**From:** Mark A. Olinger <cincygrad@yahoo.com>  
**Sent:** Monday, June 16, 2025 4:01 PM  
**To:** Oliver, Alyson E. - PDR  
**Cc:** Newbille, Cynthia I. - City Council; Patterson, Samuel - City Council Office; Alessandro Ragazzi  
**Subject:** Rezoning of M & Glenwood Area from R-5 to R-63  
**Attachments:** M & Glenwood Comments.pdf

# Glenwood to M Rezoning Request

GLENWOOD to M ST  
Richmond, VA

Proj: 2024018  
Date: 2024-01-14  
Rev: 01

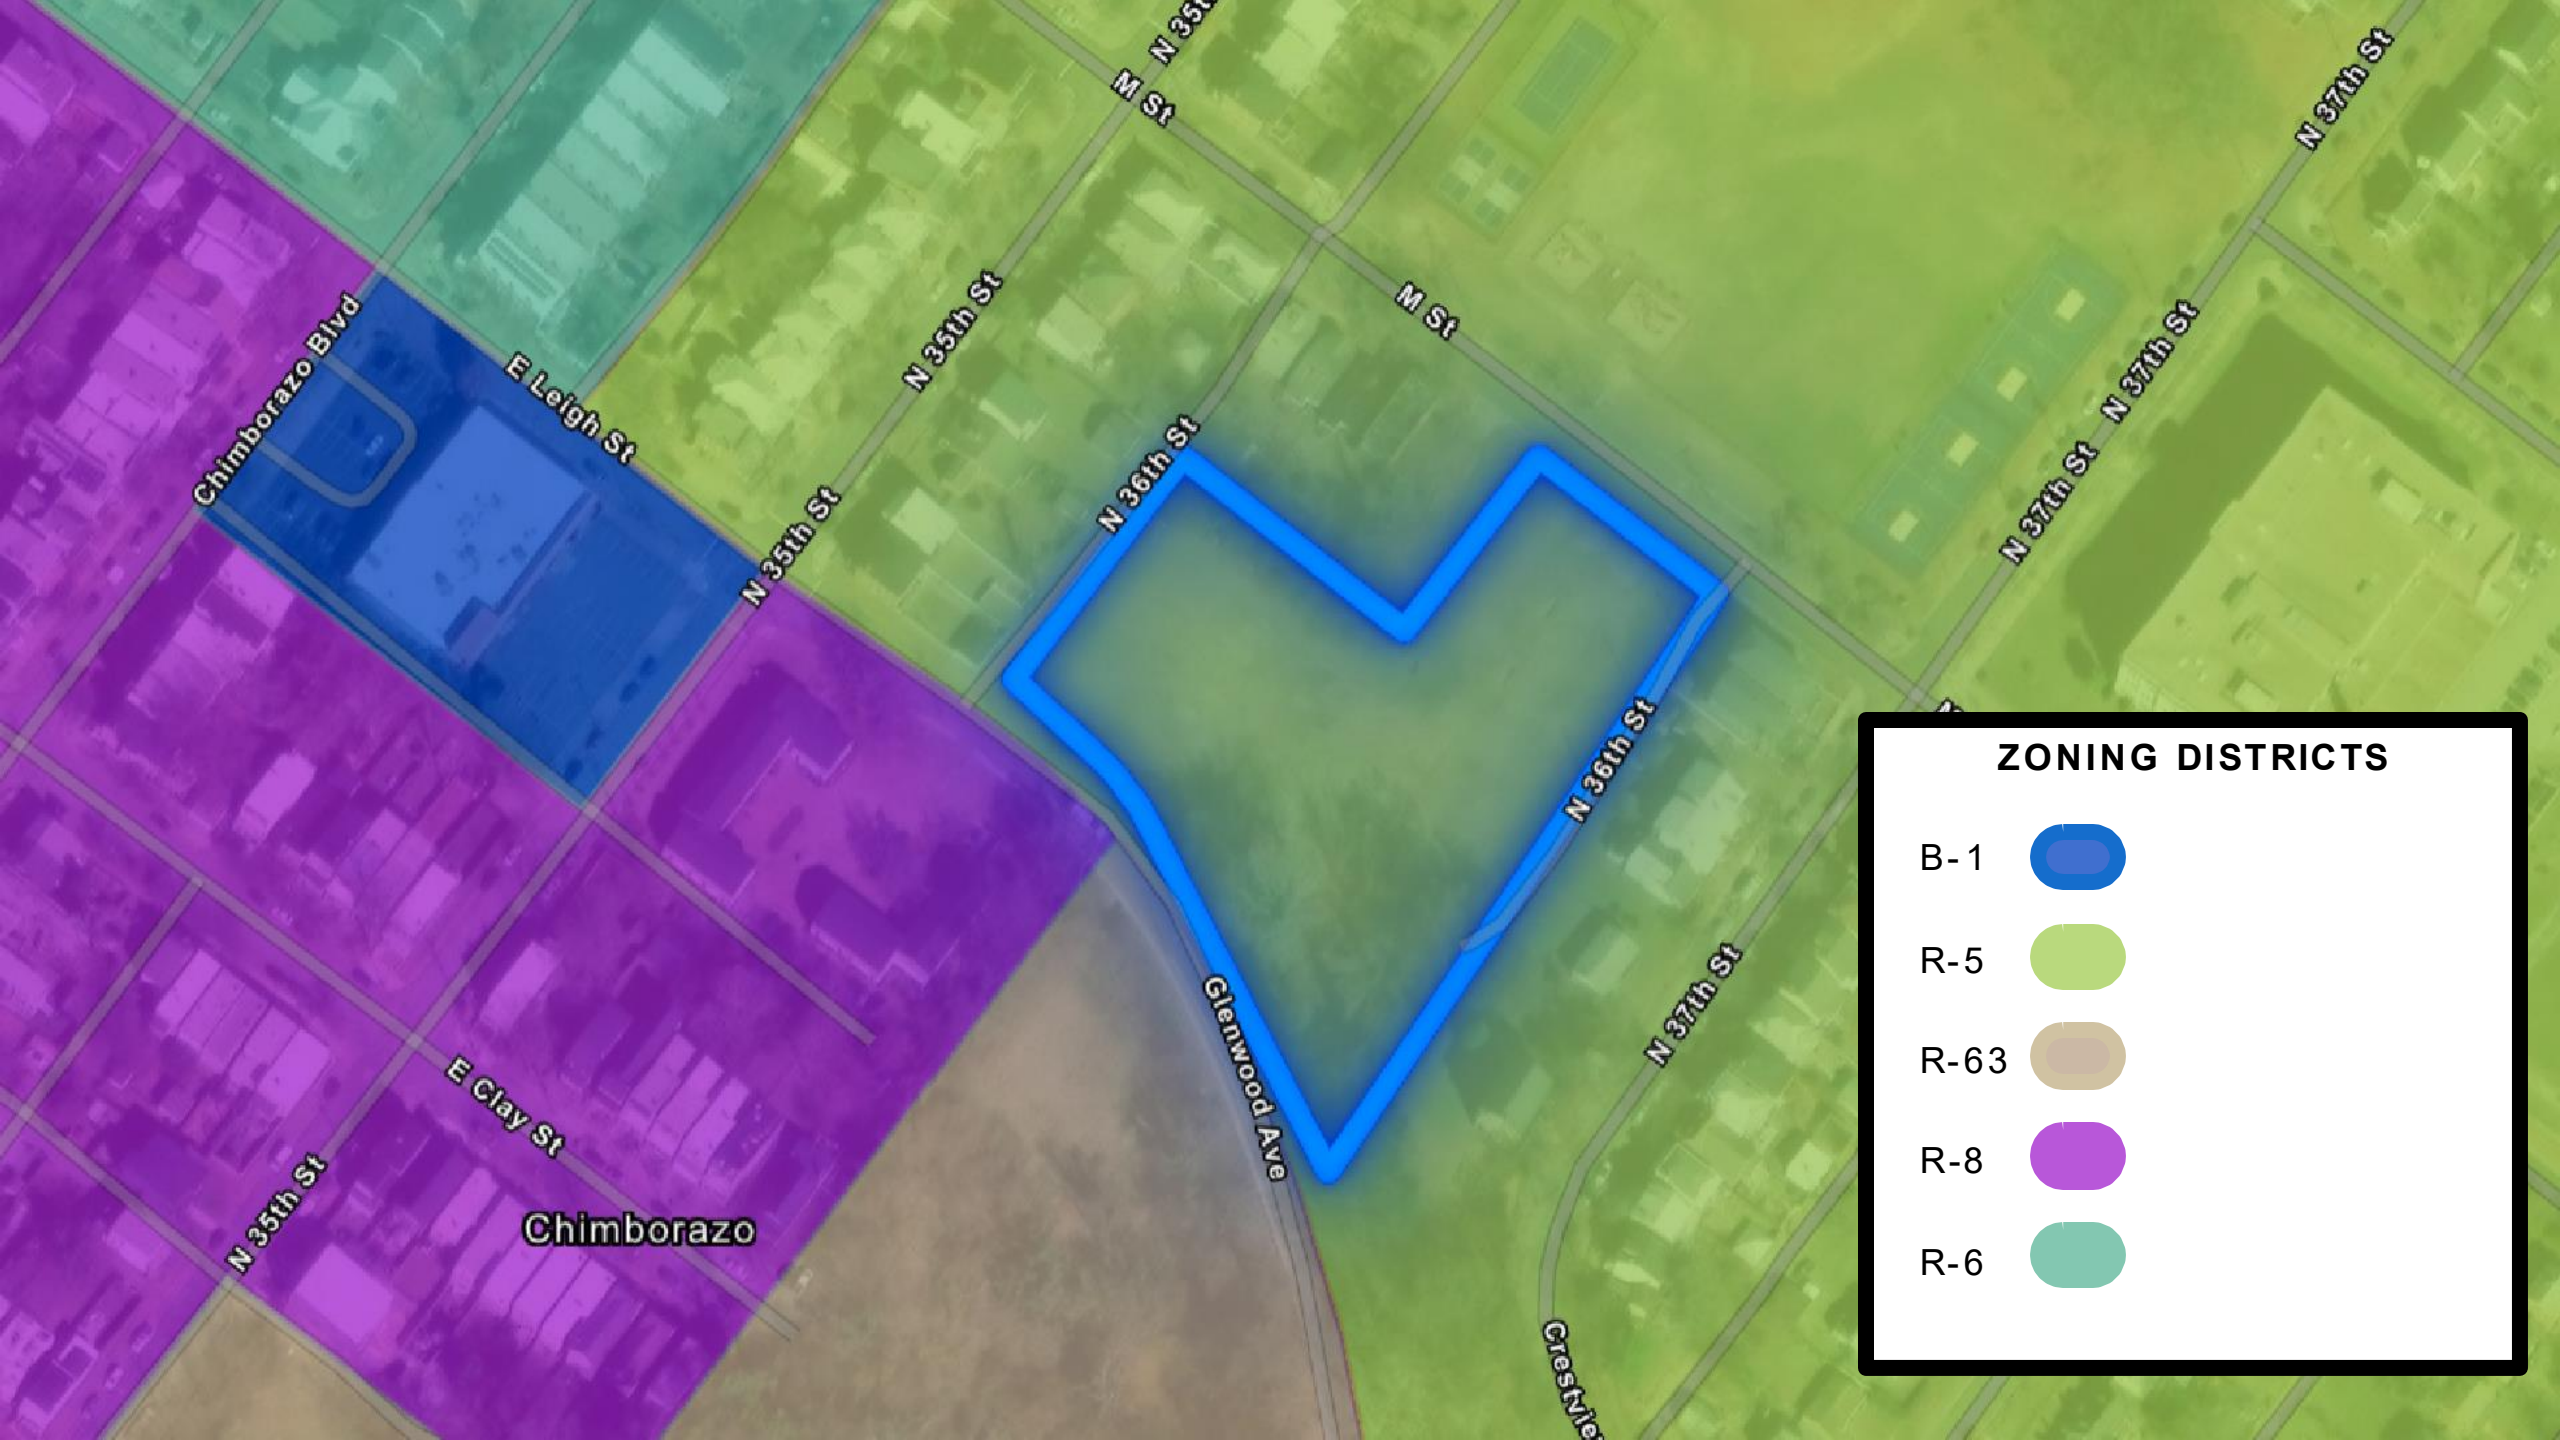
proposed lots to conform to  
R-63 MULTIFAMILY URBAN  
RESIDENTIAL lot width and area  
standards.

## R/W Sidewalk Improvements

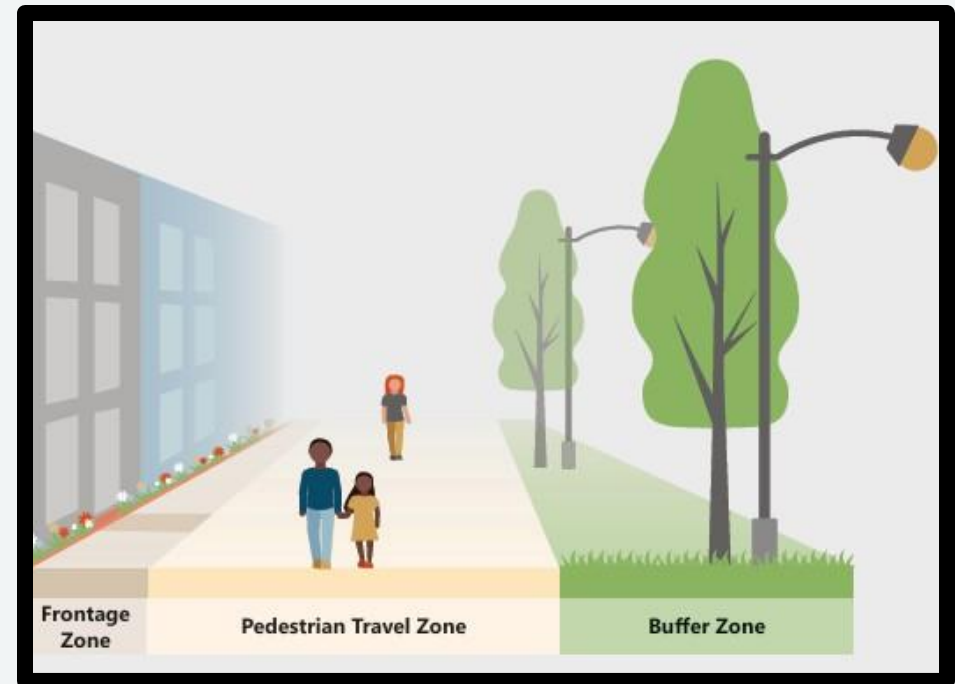
- The concept plan is not a plan; it's a lot lay-out. It could change significantly following rezoning. Don't have a clue about scale/lot sizes or unit mix..

- "Concept Plan" doesn't address topography and existing tree area fronting on Glenwood (R300, HQP, Objective 4.1.a—c., e., f., h., and i.) and how that may affect lots, access, alleys, etc. How is that to be addressed?

- Sidewalks are required on both sides of street per the Subdivision Ordinance so not sure how this rises to level of proffer. Sidewalks on M vary but are at least 6' wide along M St. frontage and use that as link to neighborhood.

- Request: Remove frontage zone and add the .5' (6") to the buffer zone for trees.
- I can't find any provision for street trees in the Subdivision Ordinance.

- Request: Amend proffer to have the development follow existing r/w frontage along M St. and Glenwood Ave. for sidewalk width and street tree locations (please see next slide) identified by Urban Forestry. With no overhead utilities, plant at minimum medium-sized trees within interior of site in addition to following Street Tree Inventory recommendations and where appropriate, large-size street trees.

- Request: Amend proffer to "Provide for minimum 1 off-street parking space" period, not "to extent practicable."
